521 HIGHWAY SITE
 MECKLENBURG COUNTY
 NORTH CAROLINA

TECH. DATA SHEET
 PETITION #2002-16

DATE: March 22, 2004

SUBJECT: Administrative Approval for Petition No. 2002-16, Crosland Commercial.

ILLUSTRATIVE SITE PLAN
 REVISIONS:
 01.18.02
 01.21.02
 4/12/02
 02.15.04

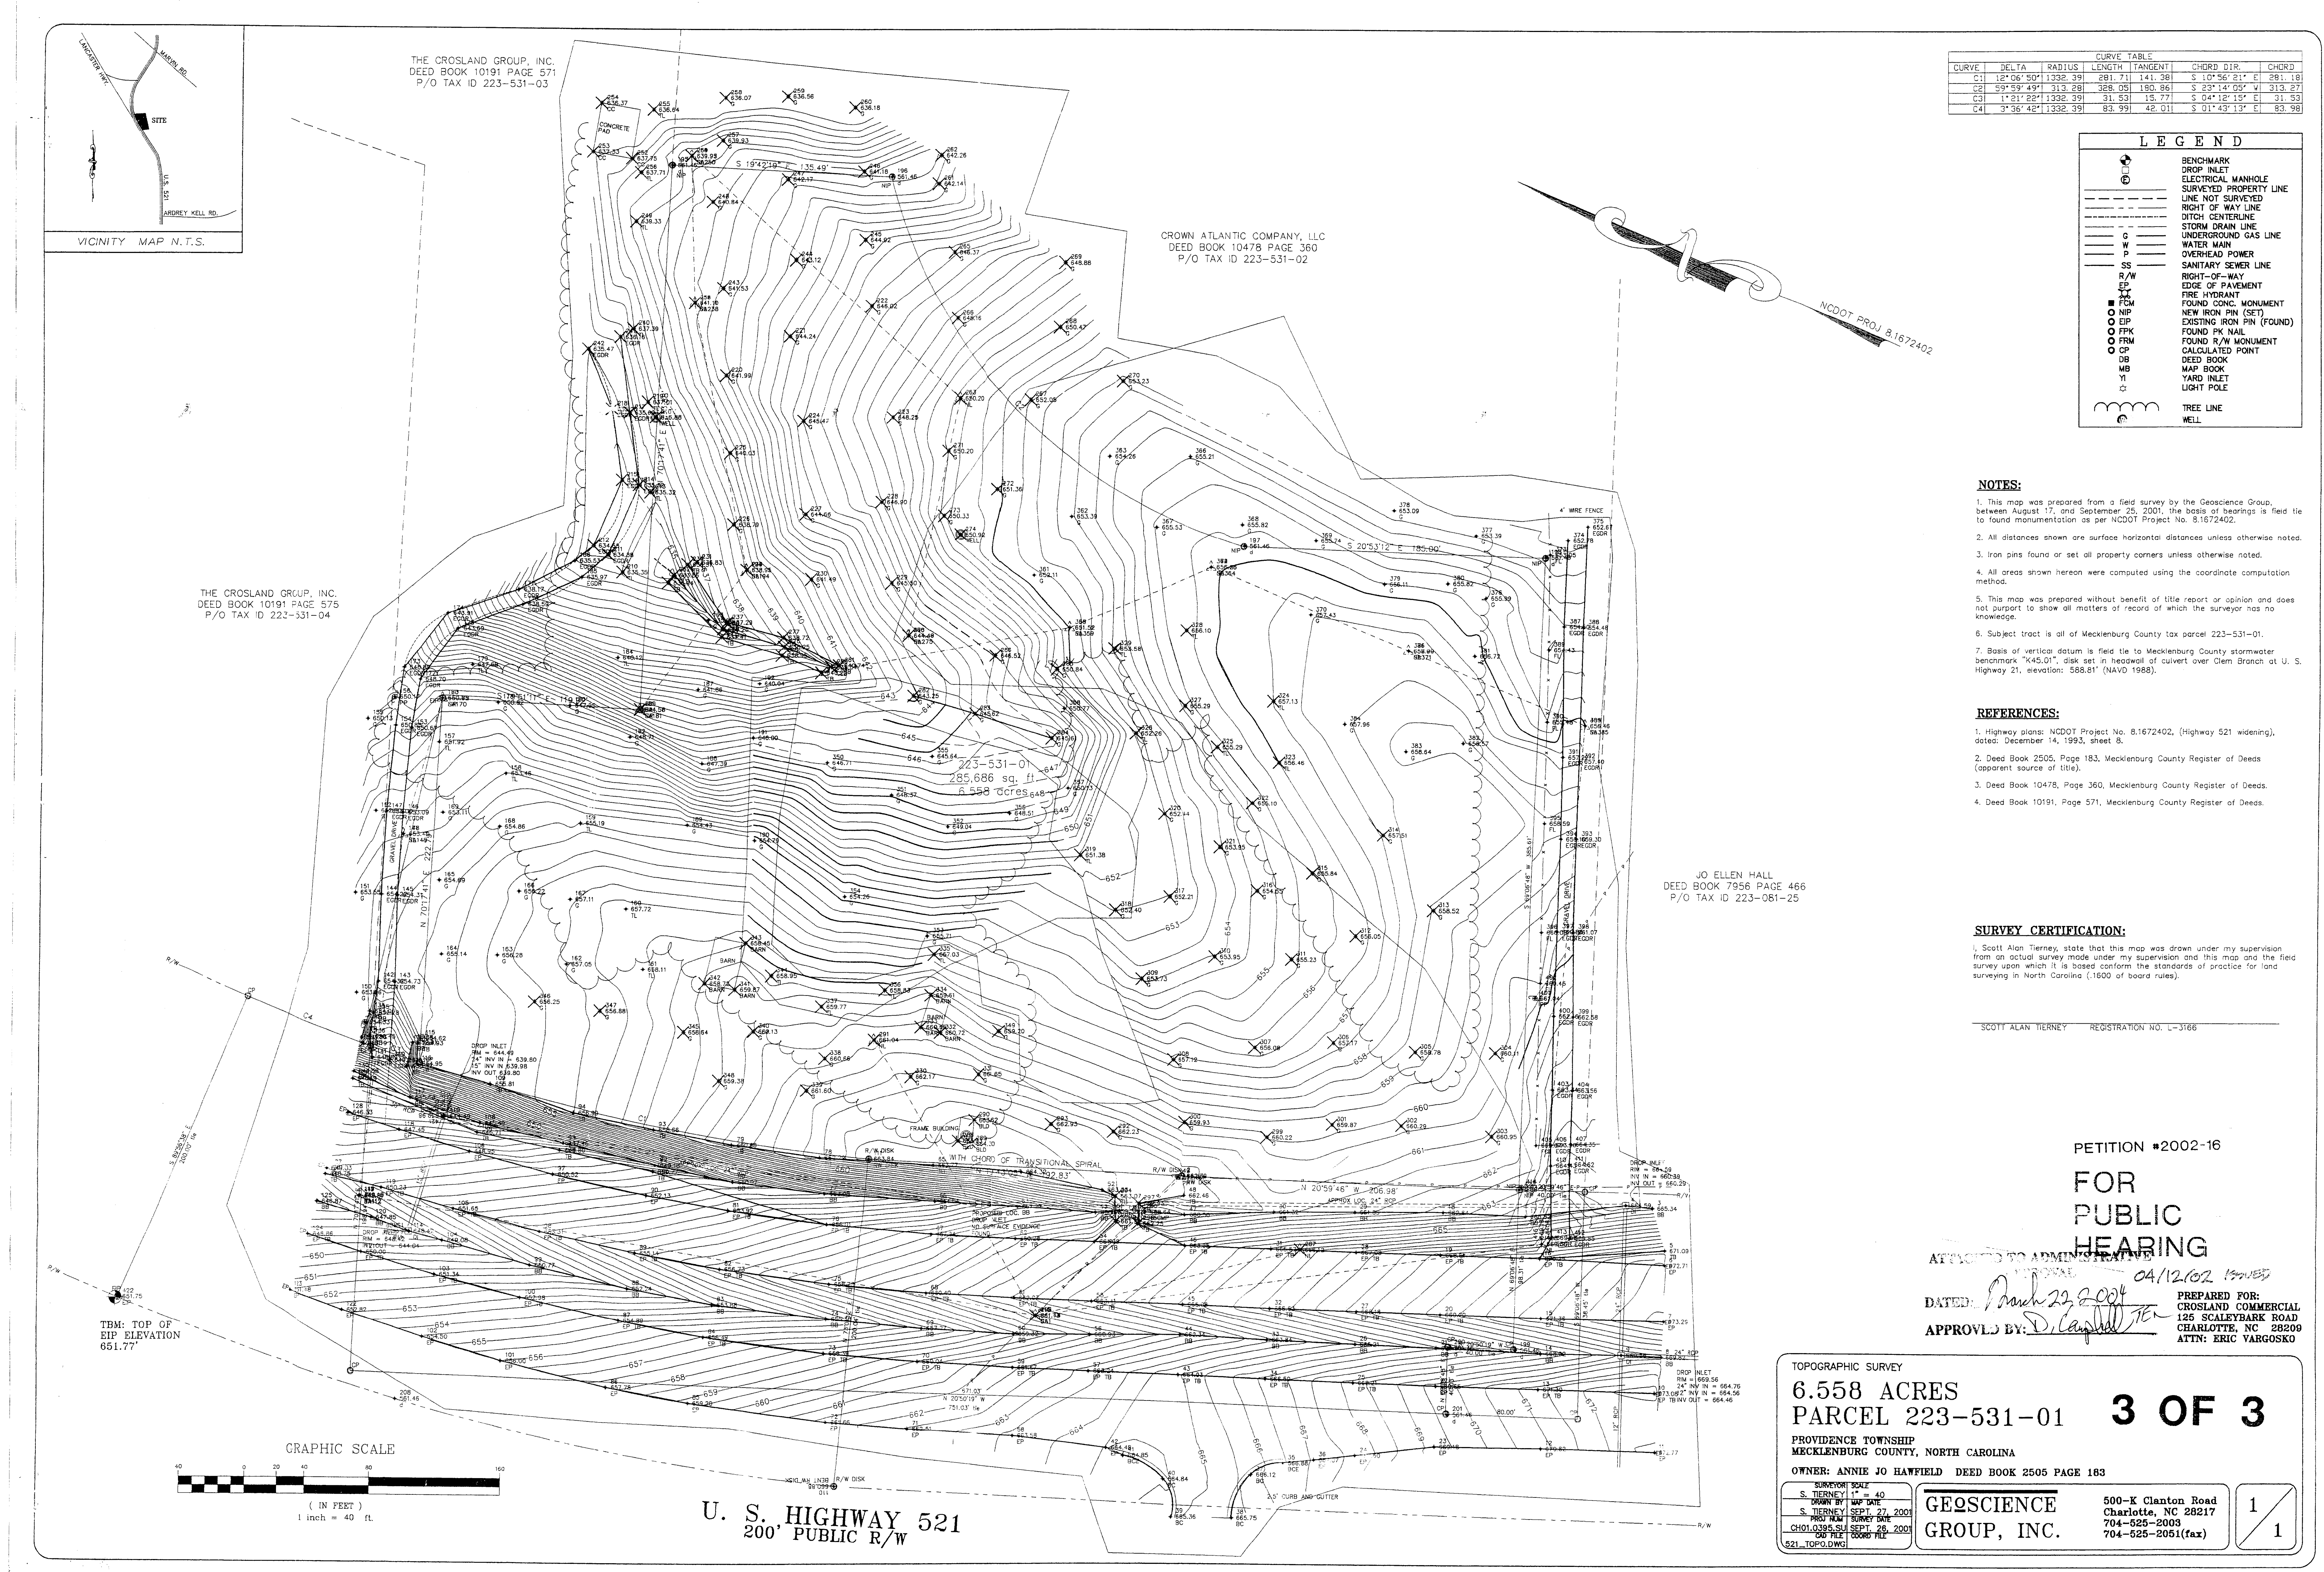
Attached are revised plans for the above petitions. Sheet 2 of 3 has been revised to reflect a reduction of the width of the interior sidewalks from 6-feet to 5-feet. Since this change is minor, I am administratively approving these revised plans. Please use these revised plans when evaluating requests for building permits and certificates of occupancy.
